711 CS-02 Before

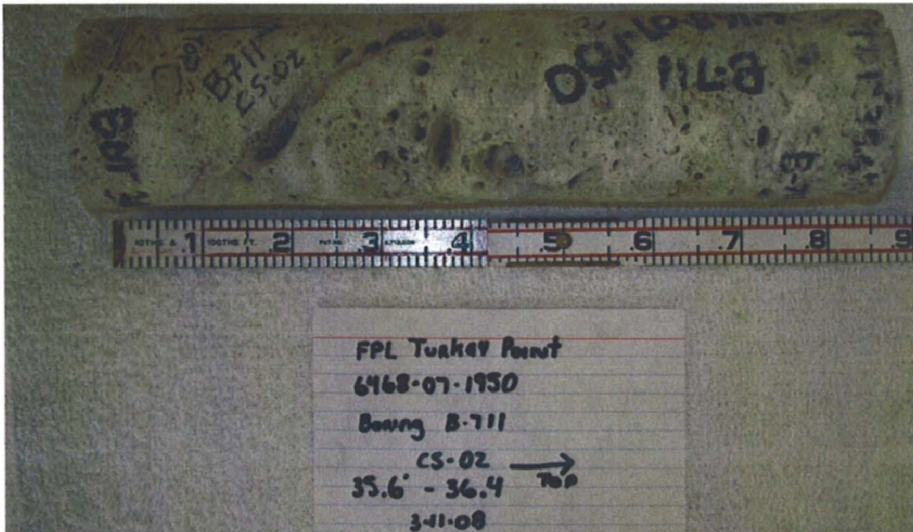
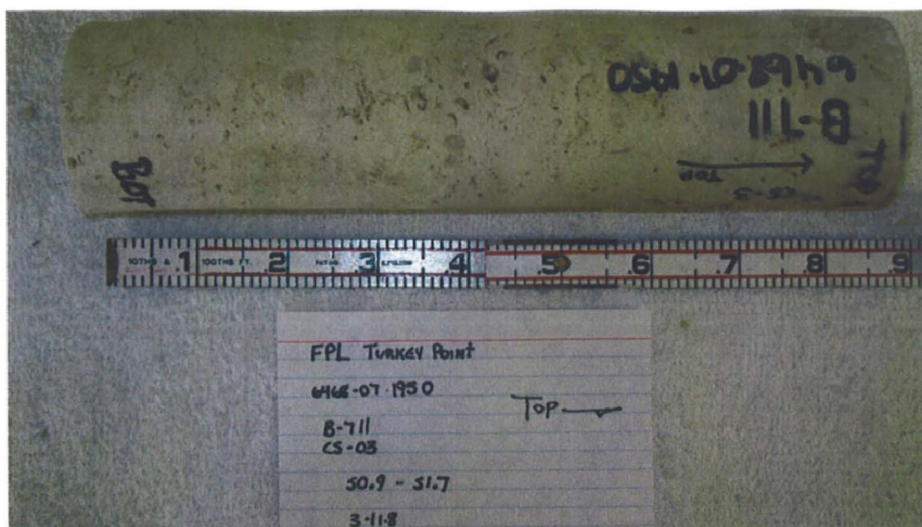
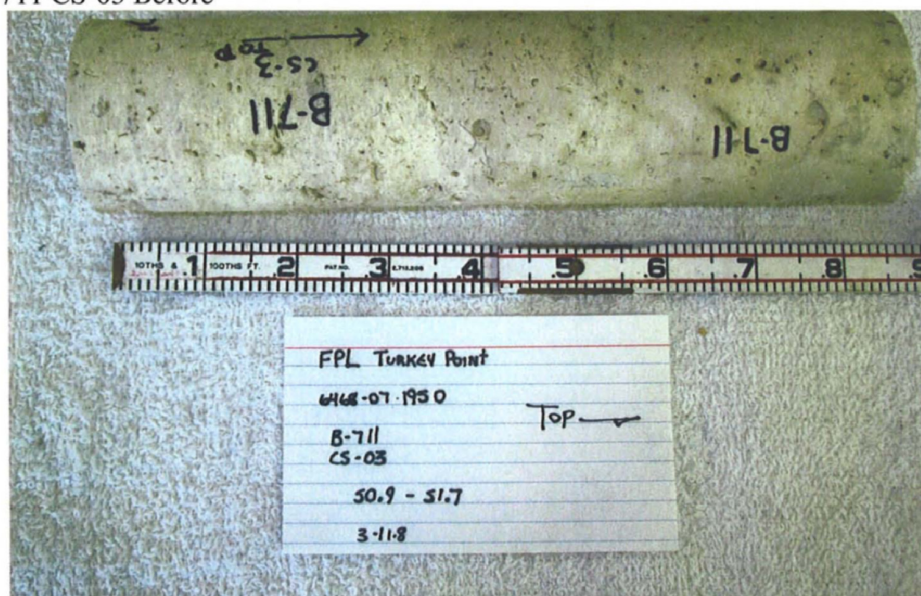
711 CS-02 Before

711 CS-02 After

711 CS-03 Before

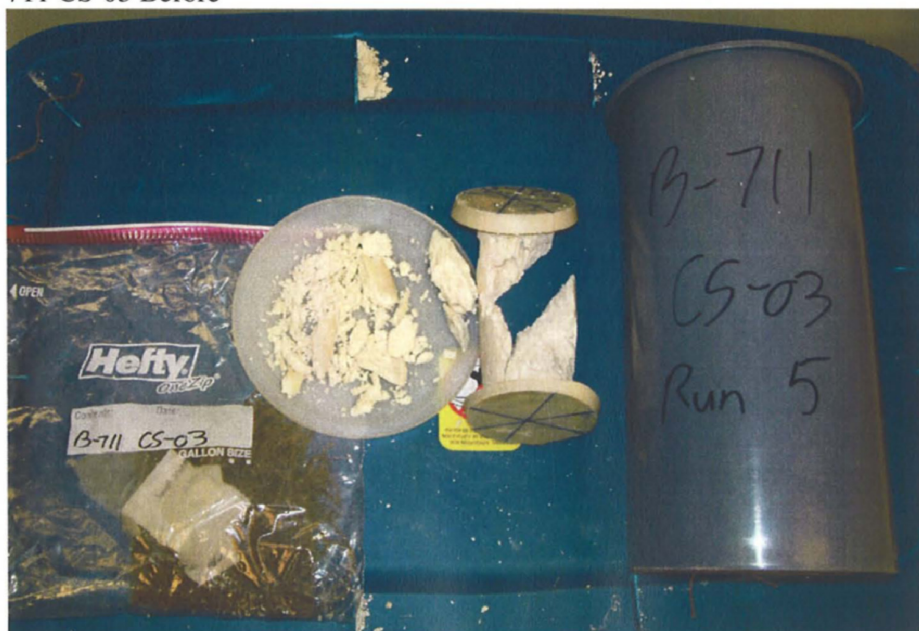
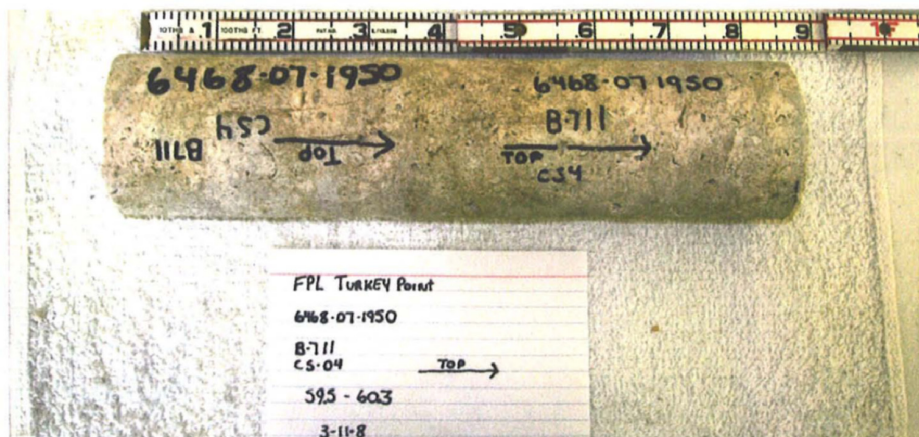
711 CS-03 Before

711 CS-03 After

711 CS-04 Before

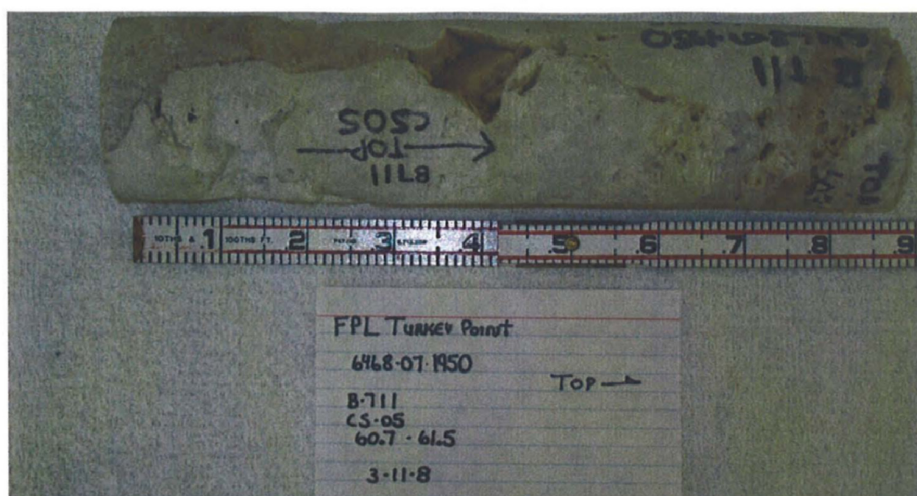
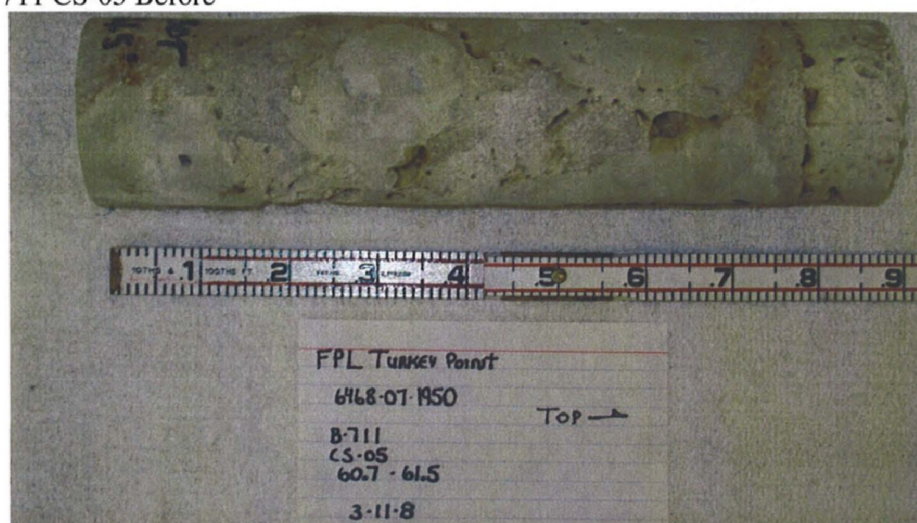
711 CS-04 After

711 CS-05 Before

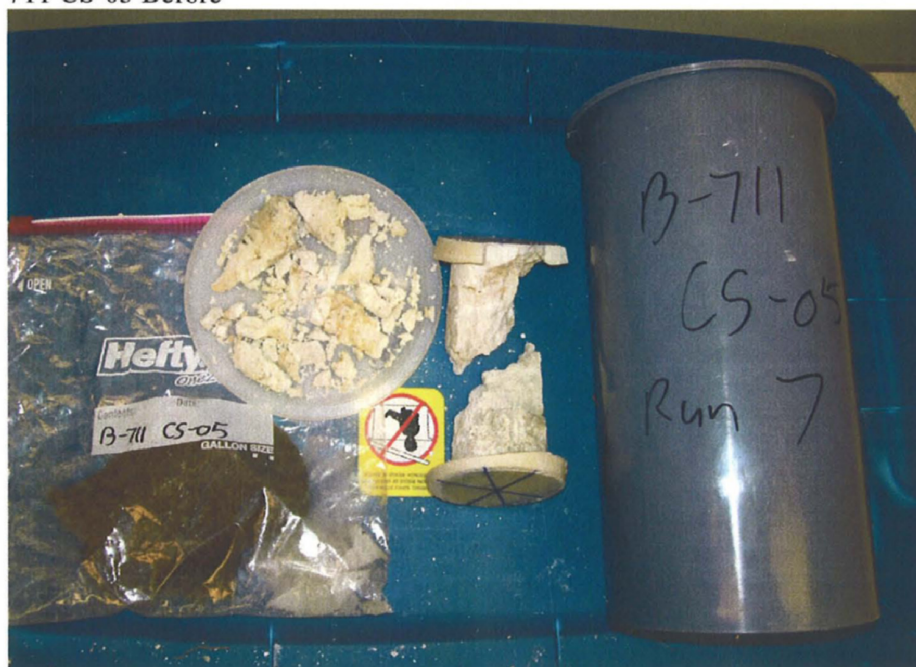
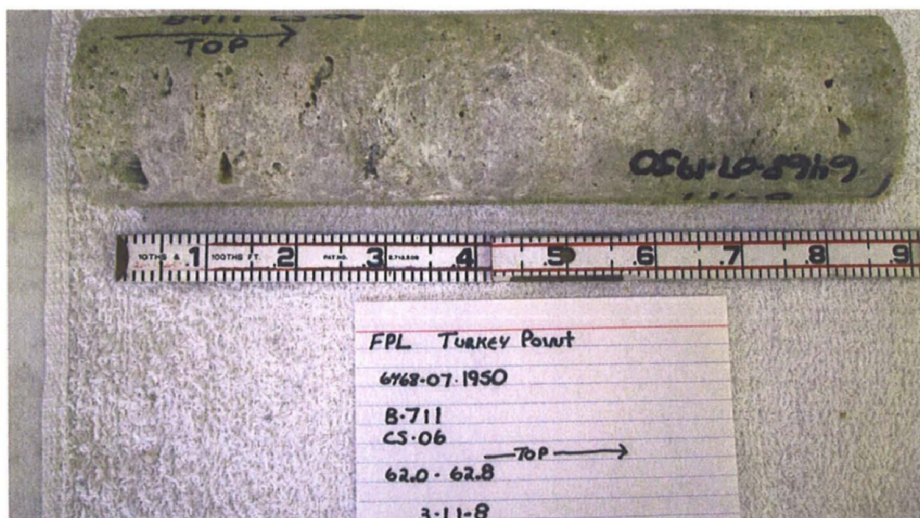
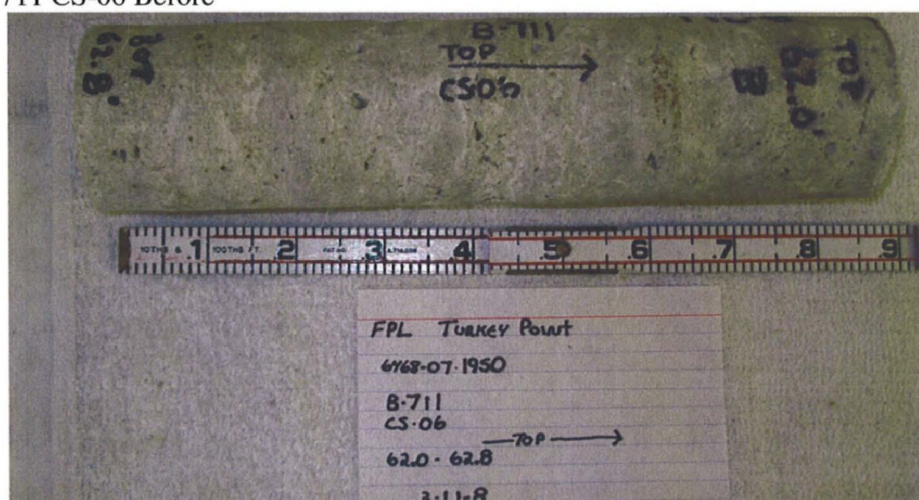
711 CS-05 Before

711 CS-05 After

711 CS-06 Before

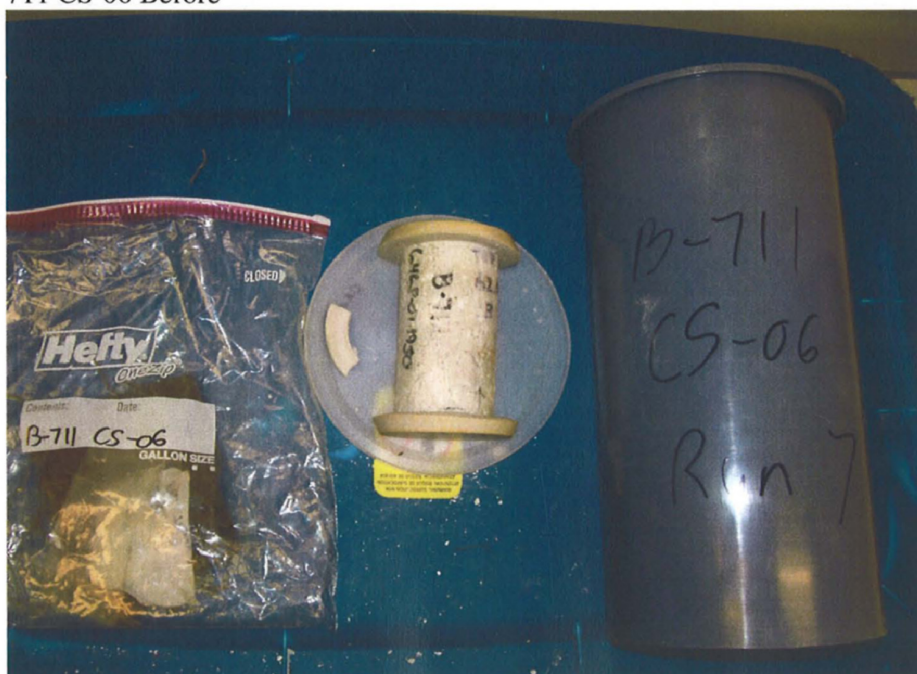
711 CS-06 Before

711 CS-06 After
